~~TRANS/WP.29/GRSP/2005/3~~  
~~7 March 2005~~

Working Party on Passive Safety (GRSP)  
(Thirty-seventh session, 23-27 May 2005,  
agenda item A.1.)

PROPOSAL FOR A GLOBAL TECHNICAL REGULATION ON  
UNIFORM PROVISIONS CONCERNING THE APPROVAL OF VEHICLES WITH REGARD  
TO THEIR CONSTRUCTION IN ORDER TO IMPROVE THE PROTECTION AND  
MITIGATE THE SEVERITY OF INJURIES TO PEDESTRIANS AND OTHER  
VULNERABLE ROAD USERS IN THE EVENT OF A COLLISION

Transmitted by the informal group on pedestrian safety

Figure 1: Bonnet Leading edge Reference Line. (see [§paragraph 3.6.](#))

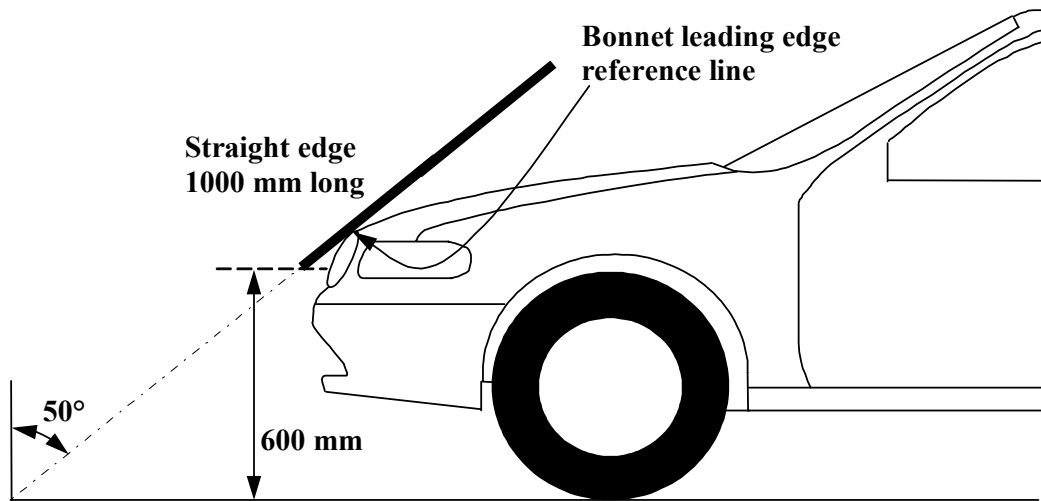
For vehicles having the bonnet top surface inclined at ~~essentially 5040°~~, so that the straight edge makes a continuous contact or multiple contacts rather than a point contact, determine the reference line with the straight edge inclined rearwards at an angle of 4035° from the vertical.
